# Work Order ID 117511

Item ID: D206-781-041 Accept \*N900040100\* Setup Start \*NS1\*  
 Revision ID: Stop \*NS2\*  
 Item Name: Baggage Compartment Protector Wall  
 Start Date: 4/24/14 Start Qty: 10.00 \*10\* Cust Item ID:  
 Required Date: 5/07/14 Req'd Qty: 10.00 \*10\* Customer:  
 Reference:

# DART SERVICE INSTRUCTION

TO AMEND INSTALLATION INSTRUCTIONS IIN-D407-781-2 REV. A OR LATER APPROVED REVISION  
AND INSTRUCTIONS FOR CONTINUED AIRWORTHINESS ICA-D407-781 REV. 3 OR LATER REVISION

**FIGURE 1 - D3879-1 BAGGAGE COMPARTMENT WALL PROTECTOR - ALTERNATE INSTALLATION**

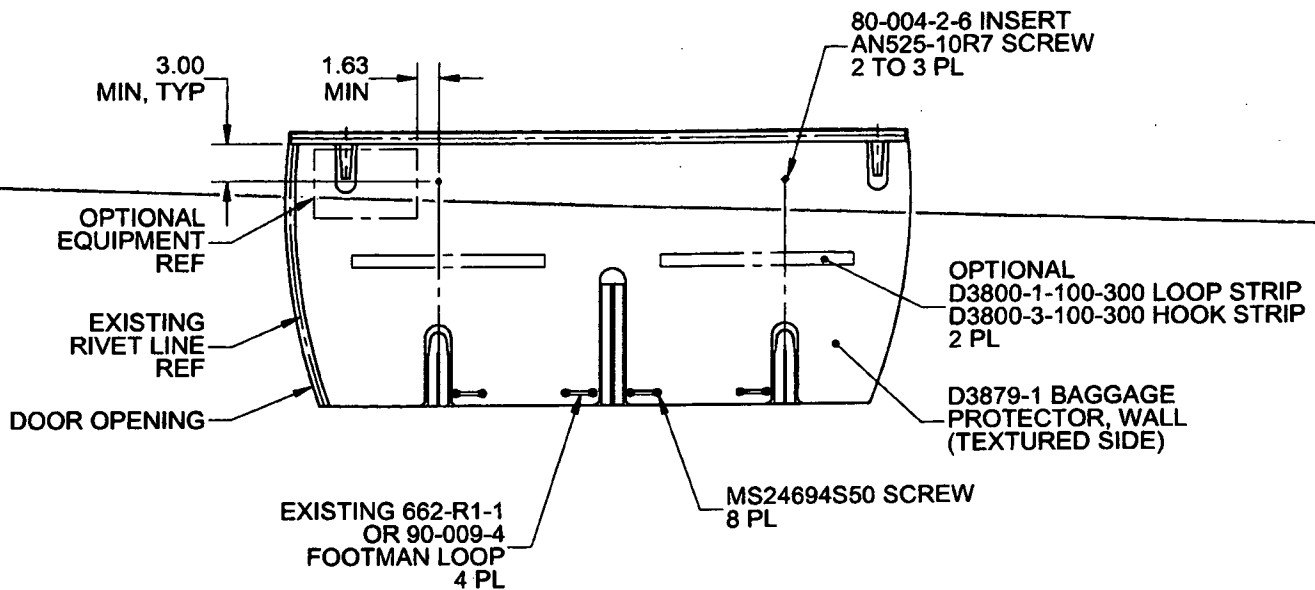
In some aircraft, the top portion of the D206-781-041 Baggage Compartment Wall Protector Kit cannot be installed as indicated in IIN-D407-781-2. The purpose of this DSI is to provide an alternate mounting method to fasten the top portion of the D206-781-041 Baggage Compartment Wall Protector Kit.

It is acceptable to replace qty(2) D3930-1 Clips with qty(2) 80-004-2-6 Inserts. Locate and mark location of the two attachment holes on the baggage compartment wall as shown in Figure 1 of this service instruction. Install 80-004-2-6 Inserts at the marked locations in accordance with Section 3-2-12 of BHT-206-SRM-1. It is acceptable to trim the wall protectors to accommodate optional equipment or transfer attachment holes to the wall protector and install the optional equipment on top of the wall protector with longer fasteners.

Amend the D206-781-041 Baggage Compartment Wall Protector Kit parts list as follows:

Qty -061	Qty -031	Qty -041	Part Number	Description
X			D206-781-061	BAGGAGE COMPARTMENT PROTECTOR KIT (FLOOR AND WALL)
1	X		D206-781-031	BAGGAGE COMPARTMENT FLOOR PROTECTOR KIT
1		X	D206-781-041	BAGGAGE COMPARTMENT WALL PROTECTOR KIT
		2	AN525-10R7	SCREW
		2	80-004-2-6	INSERT
